Product Change Notice

Manufacturer Name: Microlab

Title of Change: BK-421E – Product Specification Change

Mechanical Outline

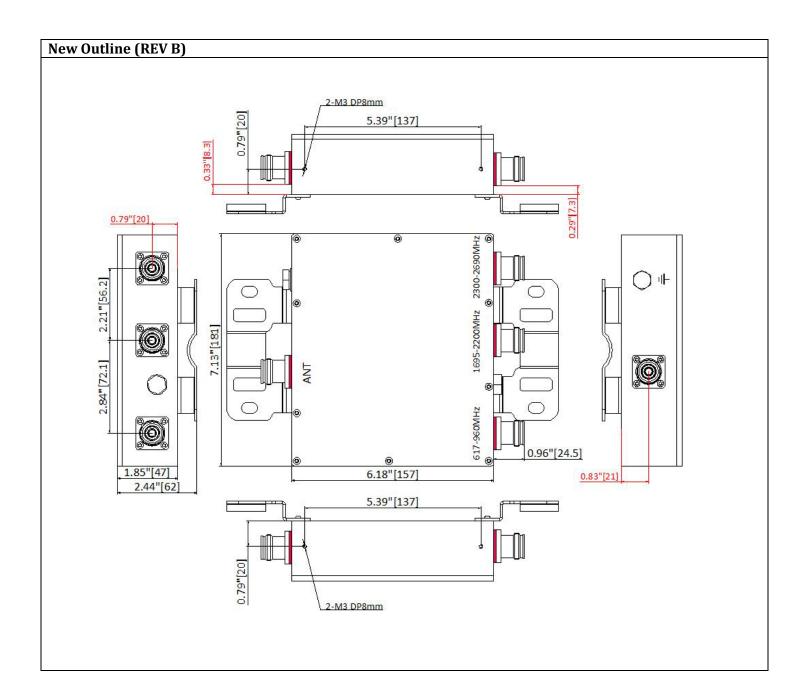
dimensions have also been revised to accommodate these frequency changes.

band (Band 71) and extending coverage for Band 66. The mechanical outline changes are necessary to integrate these enhancements while maintaining product
